This Service Information bulletin supersedes SI B63 04 13 **dated February 2013.**

Moisture in LED Headlight

NEW F01 (7 Series Sedan)

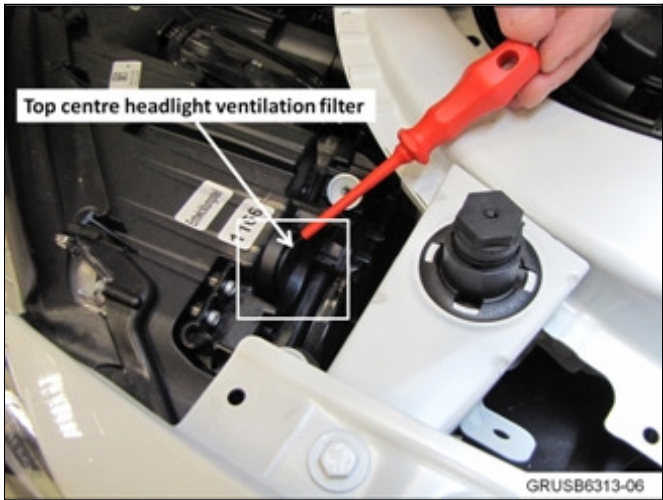
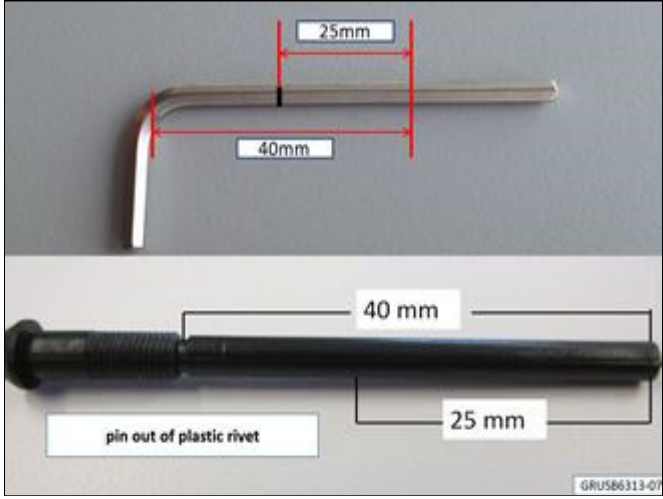
Water enters the headlight from the headlight ventilation filter.

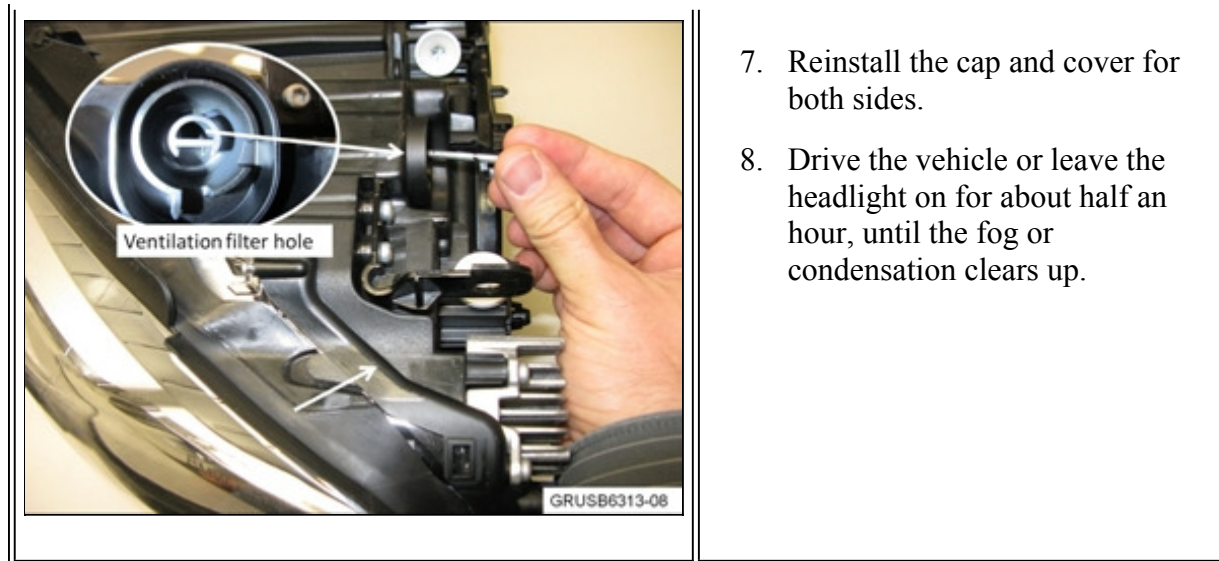
NEW CORRECTION

Remove filter from ventilation hole.

Do not replace the headlight. Follow the modification procedure below to remove the ventilation filter:

|  | <ol style="list-style-type: none"> 3. To remove the headlight ventilation filter, use a 3 mm Allen wrench. <p>Note: A pin from a plastic body rivet which is 3 mm in diameter will also work.</p> <ol style="list-style-type: none"> 4. The Allen wrench or plastic body rivet pin should be 40 mm long (allowable clearance for the tool in the vehicle). Mark 25 mm of the 40 mm length with paint or something similar: this is the depth limit inside the ventilation filter hole in order to remove the filter. |
| | <ol style="list-style-type: none"> 5. Insert the 3 mm diameter pin (or Allen wrench) 25 mm into the hole, displacing the filter as shown in the photo. Repeat this process several times. Note: The filter remains inside the headlight, but is no longer needed. 6. Perform this procedure for the other side. |
